SWIM PROJECT PROFILE		File No. : 194
Regist. No. : Agency No. : BSWM-113	Name: LABOON SWIP	
Region: 8	Province: SOUTHERN LEYTE	Municipality: MAASIN
Present Status: 1. Pre-F/S( )    ② F/S(1983)    ③ D/D(1983)		
Purpose: Major : Irrigation Incidental : IF, FC, WM		
Project Feature:

SWIM PROJECT PROFILE		File No. : 195
Regist. No. : Agency No. : BSWM-114	Name: POLANQUI SWIP	
Region: 8	Province: EASTERN SAMAR	Municipality: TAFT
Present Status: 1. Pre-F/S( ) ② F/S(1983) ③ D/D(1983)		
Purposo: Major : Irrigation Incidental : IF, FC, WM		
Project Feature:

SWIM PROJECT PROFILE		File No. : 204
Regist. No. : Agency No. : BSWM-124	Name: LUBUANGON SWIP	
Region: 10	Province: BUKIDNON	Municipality: KIBAWÉ
Present Status: 1. Pre-F/S( )    ② F/S(1983)    ③ D/D(1983)		
Purpose: Major : Irrigation Incidental : IF, FC		
Project Feature:

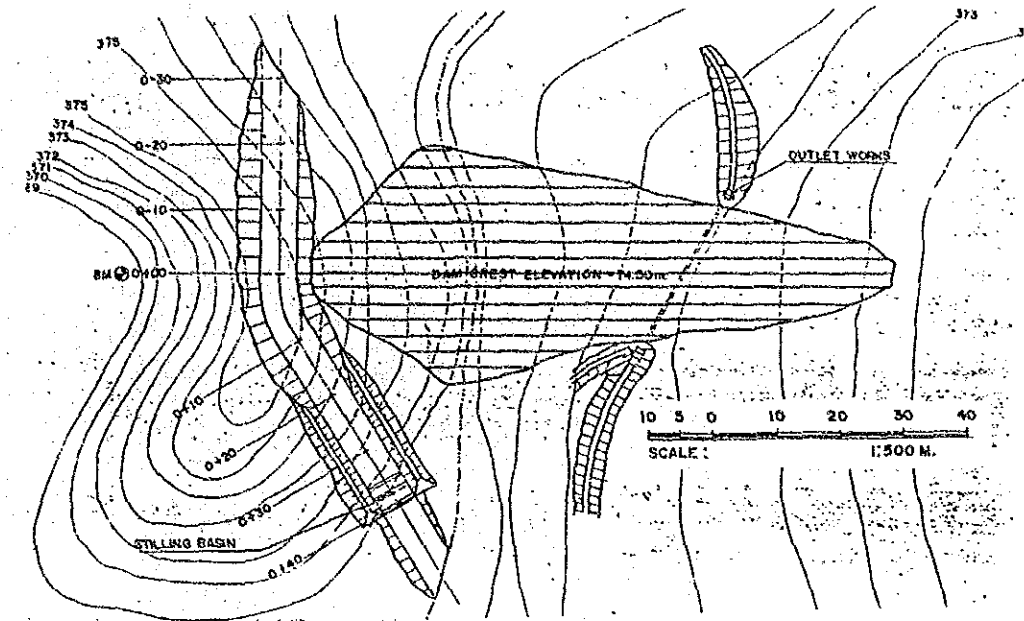
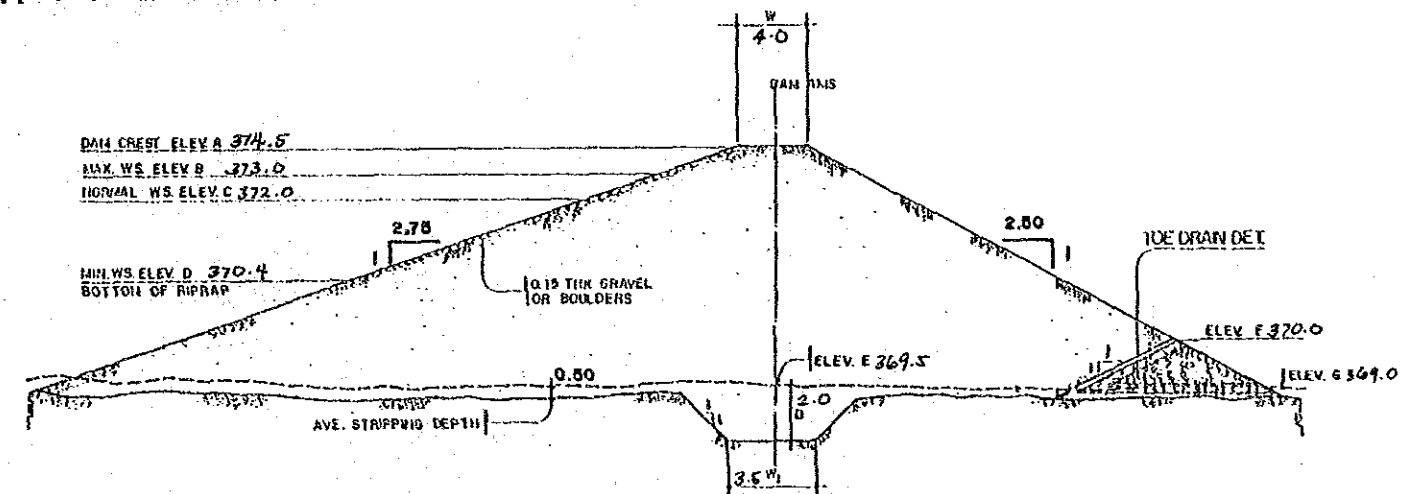
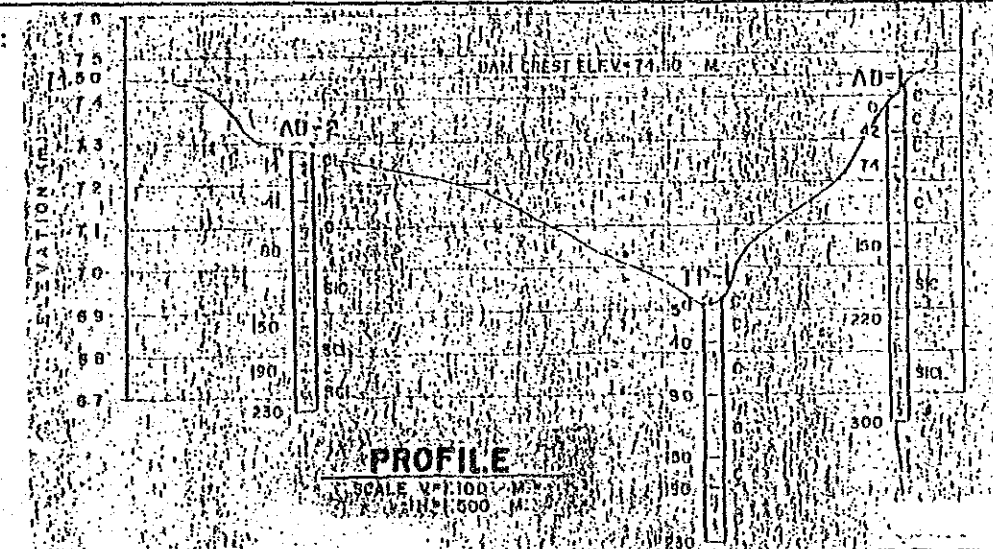
6. Inland Fishery	Annual Production :	5 ton/year
Technical Assessment:		
1. Survey and Investigation: Depth of test pit or auger boring is not enough. Bearing capacity and permeability are not measured. Available volume for dam embankment shall be studied before construction.

2. Planning Environmental conservation plan is not formulated.		
3. Design Depth of core trench shall be modified during construction. Stability of upstream slope of the dam shall be checked. analysis. Center line of the spillway shall be shifted to right side. Weir shall be provided in the spillway.

SWIM PROJECT PROFILE		File No. : 205
Regist. No. : Agency No. : BSWM-125	Name: ALUBIJID SWIP	
Region: 10	Province: AGUSAN DEL NORTE	Municipality: BUENAVISTA
Present Status: 1. Pre-F/S( ) (2) F/S(1983) (3) D/D(1983)		
Purpose: Major : Irrigation Incidental : IF, FC, WM		
Project Feature:

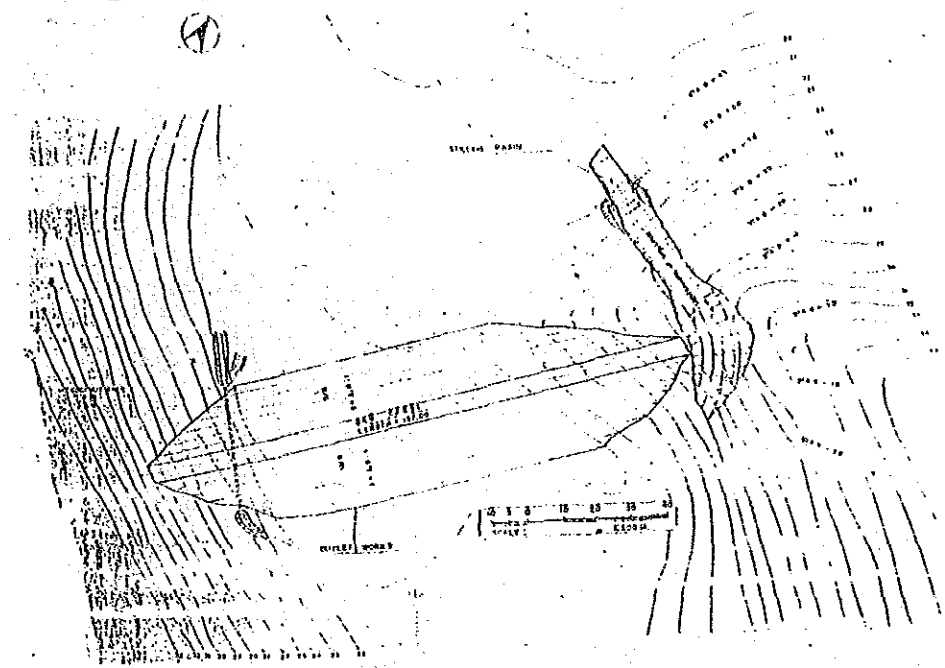
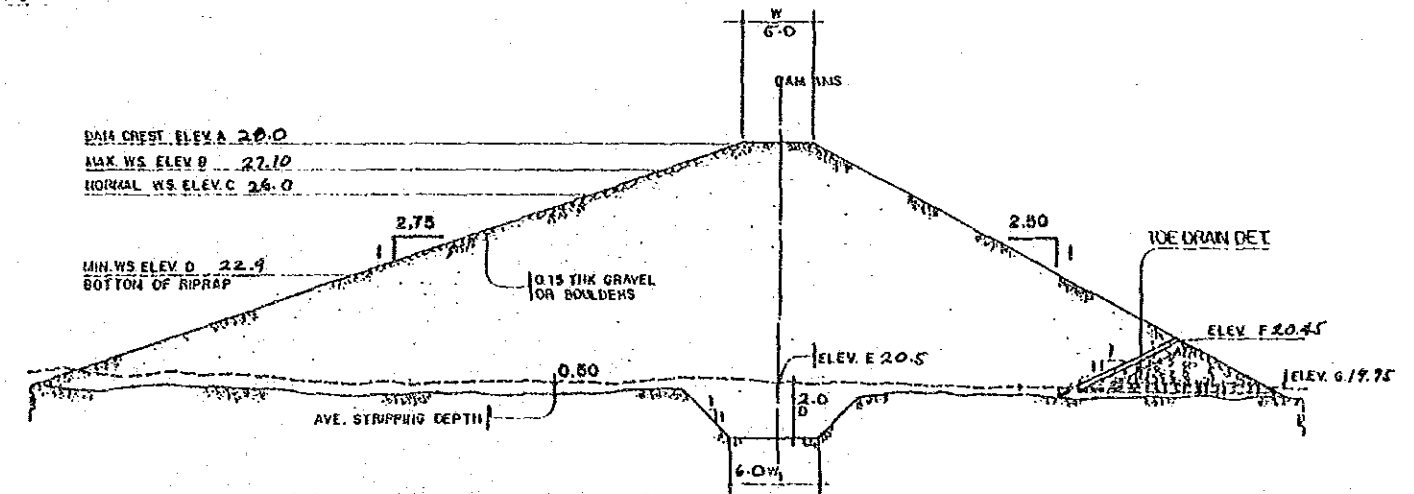
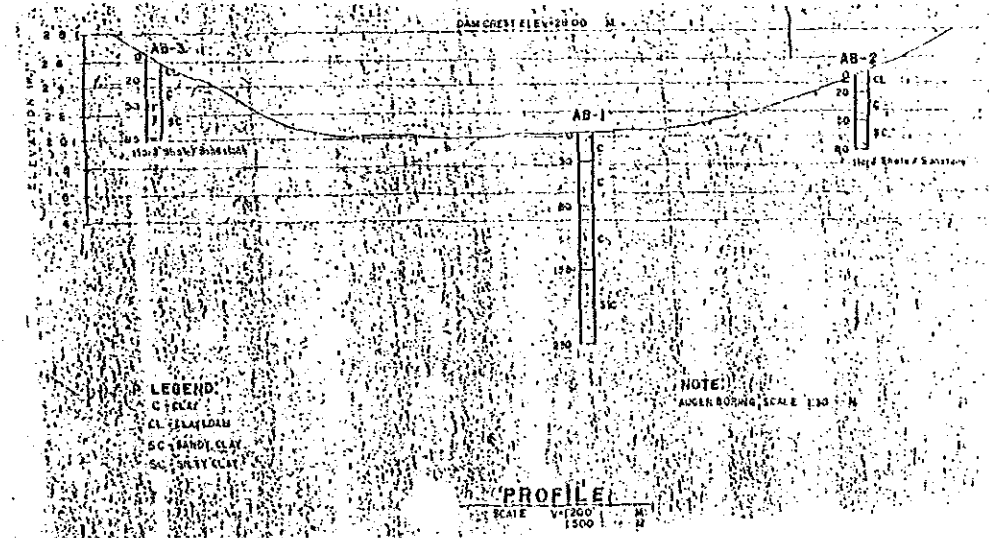
6. Inland Fishery	: Annual Production	: 6 ton/year
Technical Assessment:		
1. Survey and Investigation: Depth of test pit or auger boring is not enough. Bearing capacity and permeability are not measured. Available volume for dam embankment shall be studied before construction.

2. Planning Environmental conservation plan is not formulated.		
3. Design Depth of core trench shall be modified during construction. Stability of upstream slope of the dam shall be checked. Weir shall be provided in the spillway.

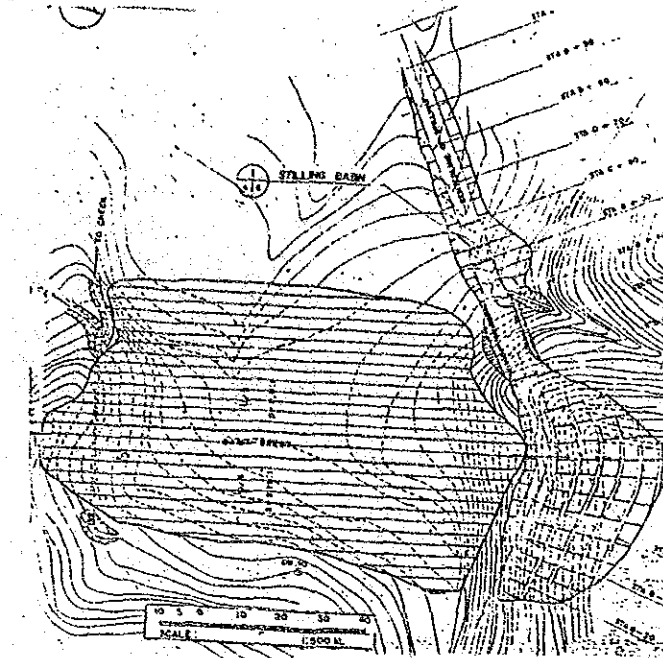
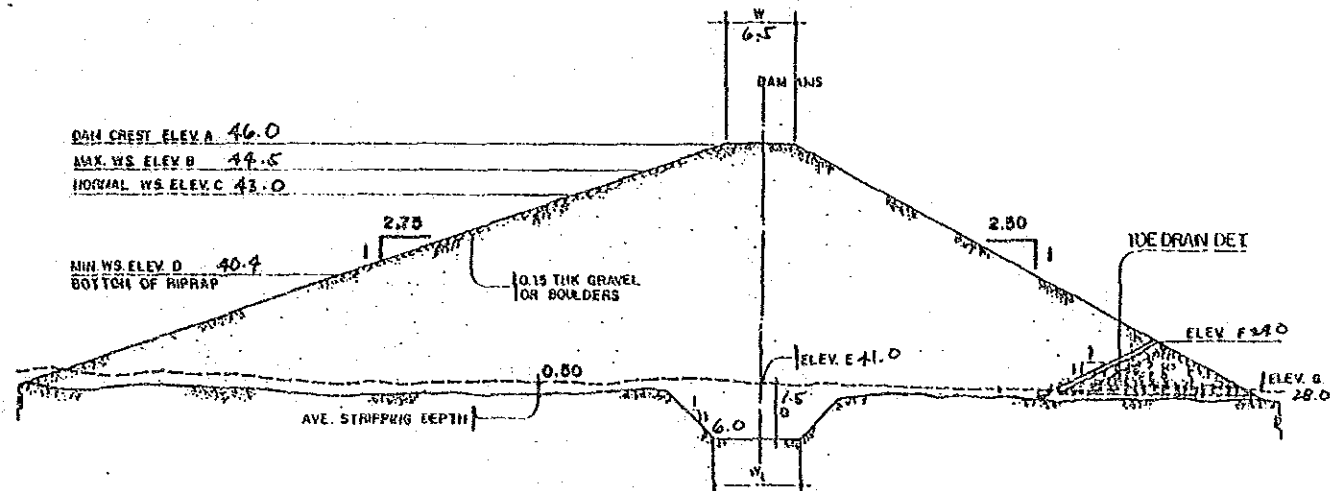
6. Inland Fishery	: Annual Production	: 2 ton/year
Technical Assessment:		
1. Survey and Investigation: Depth of test pit or auger boring is not enough. Bearing capacity and permeability are not measured. Available volume for dam embankment shall be studied before construction.

2. Planning Environmental conservation plan is not formulated.		
3. Design Depth of core trench shall be modified during construction. Stability of upstream slope of the dam shall be checked. Weir shall be provided in the spillway.

SWIM PROJECT PROFILE		File No. : 207
Regist. No. : Agency No. : BSWM-127	Name : APULANG SWIP	
Region : 10	Province : BUKIDNON	Municipality : KIBAWÉ
Present Status: 1. Pre-F/S( )    ② F/S(1983)    ③ D/D(1983)		
Purpose: Major : Irrigation Incidental : IF, FC, WM		
Project Feature:

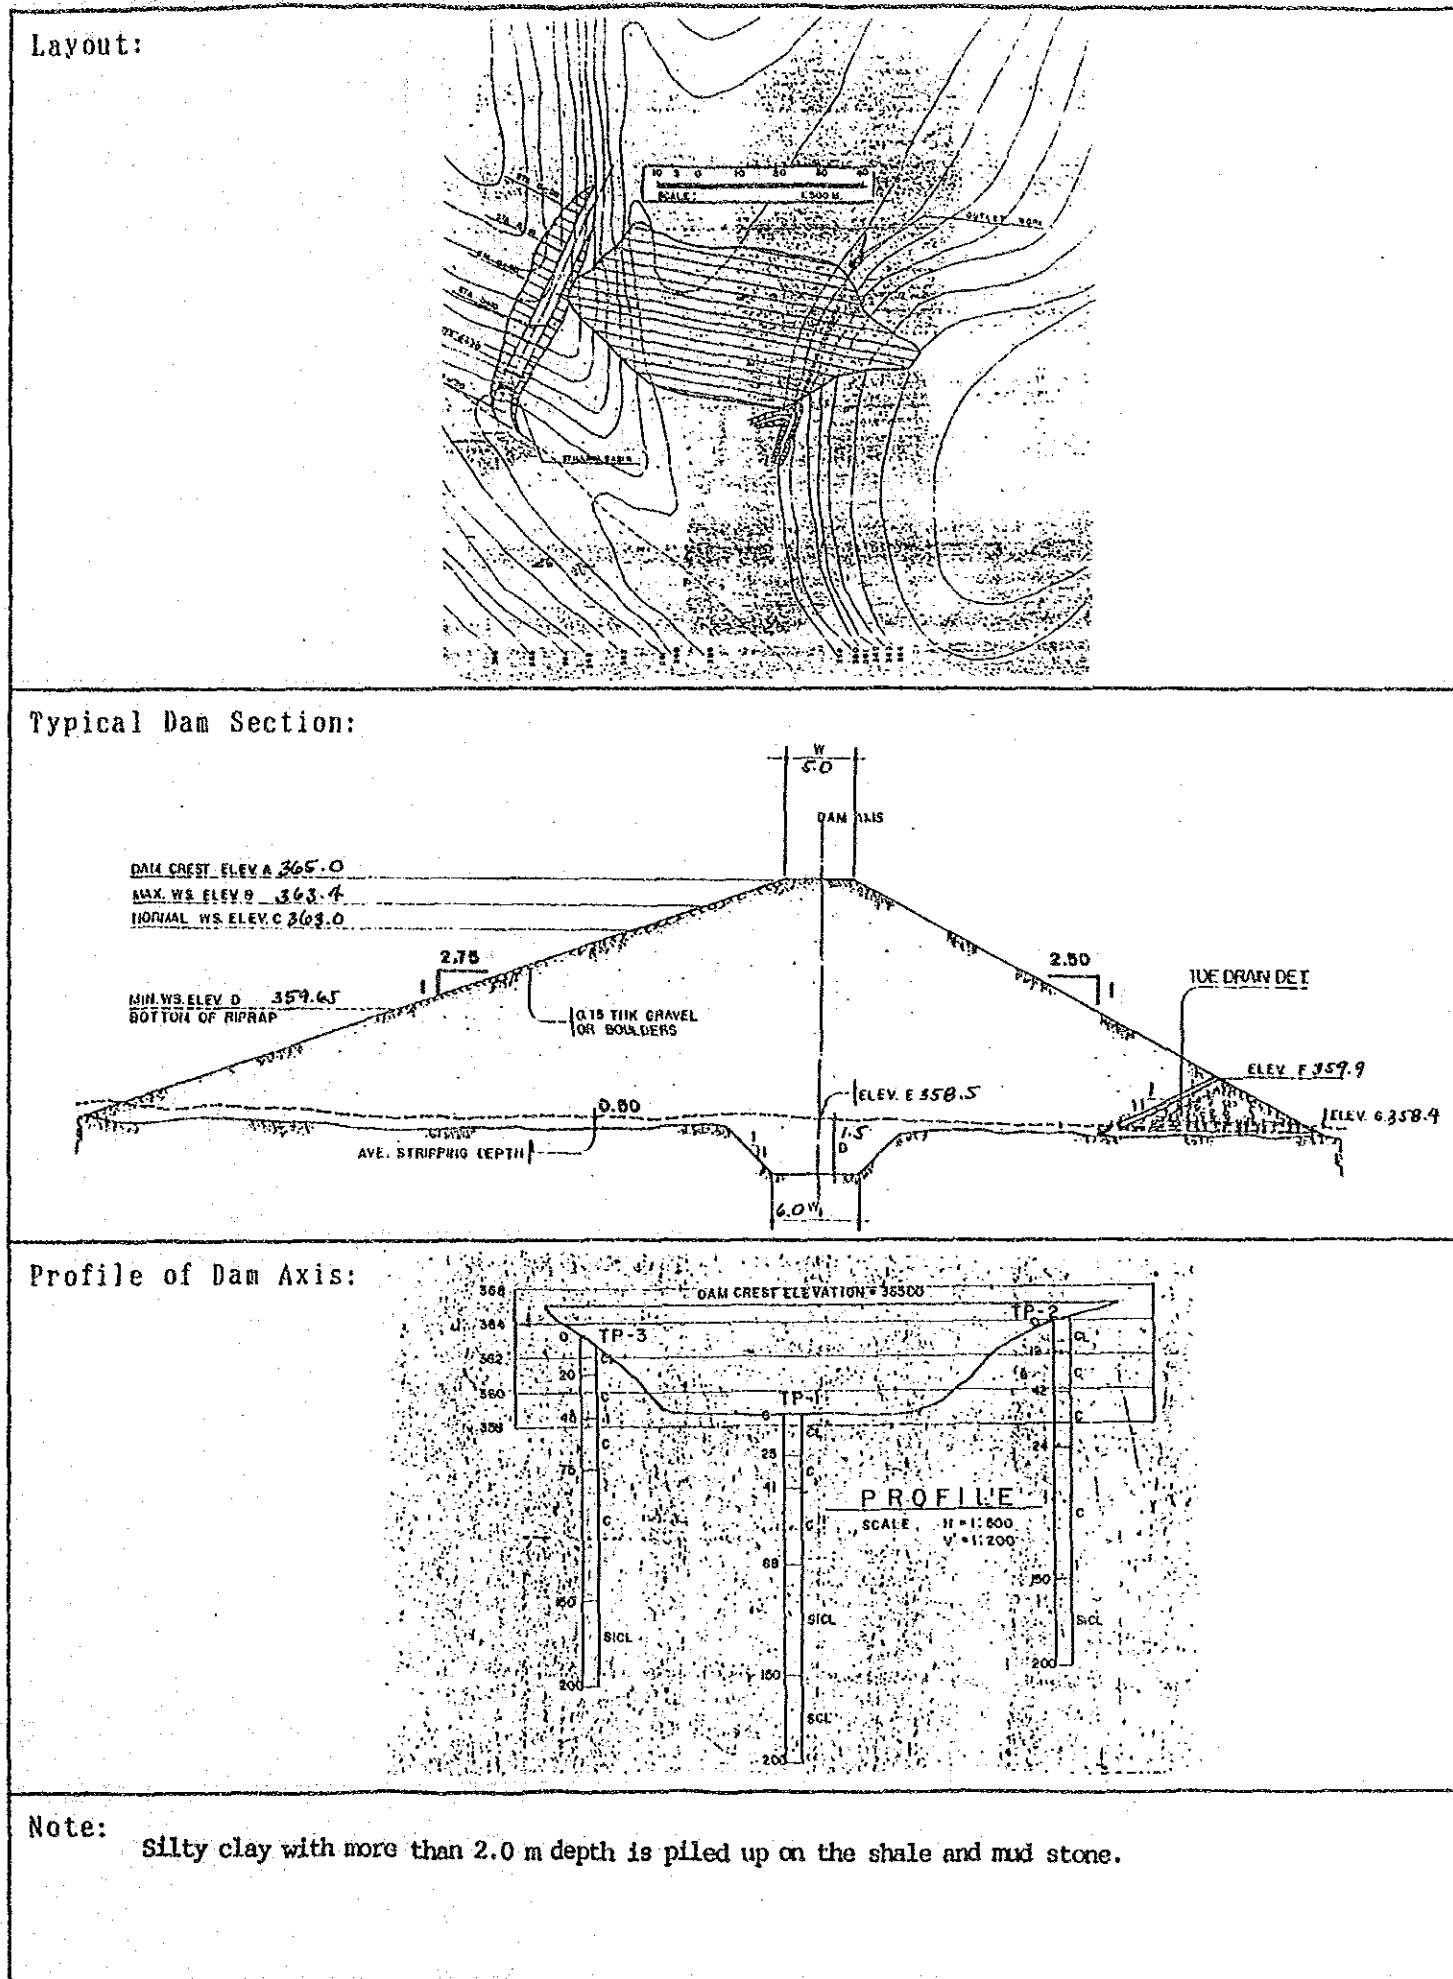
6. Inland Fishery	: Annual Production	: 11 ton/year
Technical Assessment:		
1. Survey and Investigation: Depth of test pit or auger boring is not enough. Bearing capacity and permeability are not measured. Available volume for dam embankment shall be studied before construction.

2. Planning Environmental conservation plan is not formulated.		
3. Design Depth of core trench shall be modified during construction. Stability of upstream slope of the dam shall be checked. Weir shall be provided in the spillway.

SWIM PROJECT PROFILE		File No. : 208
Regist. No. : Agency No. : BSWM-128	Name: TALAO-AO SWIP	
Region: 10	Province: AGUSAN DEL NORTE	Municipality: BUENAVISTA
Present Status: 1. Pre-F/S( ) (2) F/S(1983) (3) D/D(1983)		
Purpose: Major : Irrigation Incidental : IF, FC, WM		
Project Feature:

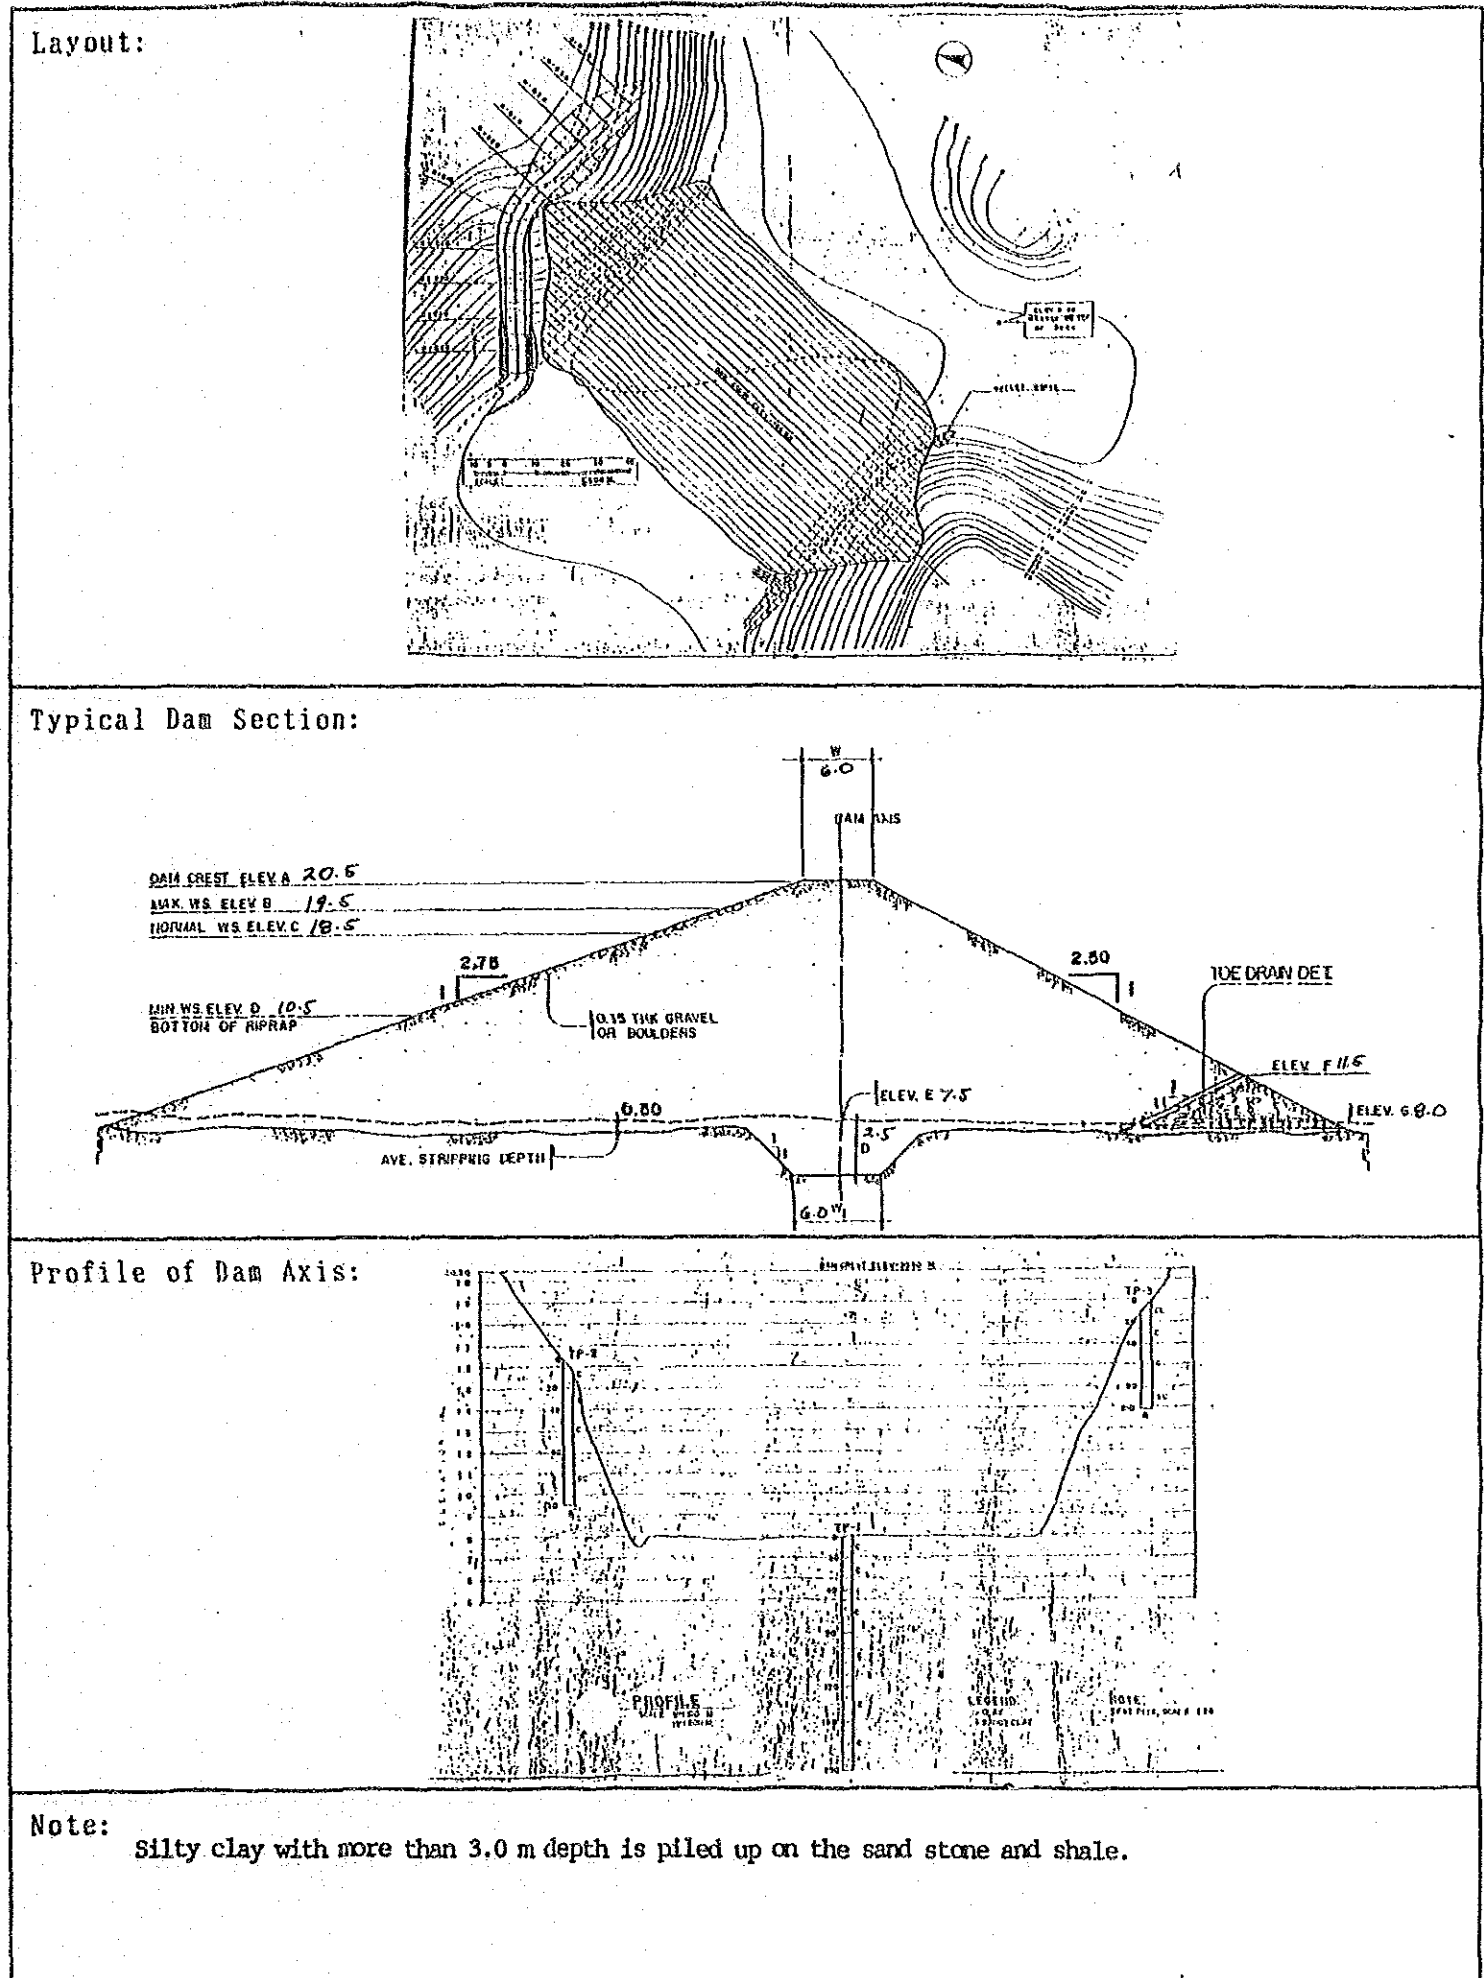
6. Inland Fishery	: Annual Production	: 11 ton/year
Technical Assessment:		
1. Survey and Investigation: Depth of test pit or auger boring is not enough. Bearing capacity and permeability are not measured. Available volume for dam embankment shall be studied before construction.

2. Planning Environmental conservation plan is not formulated.		
3. Design Depth of core trench shall be modified during construction. Stability of upstream slope of the dam shall be checked. Weir shall be provided in the spillway. Center line of conduit is recommended to be straight.
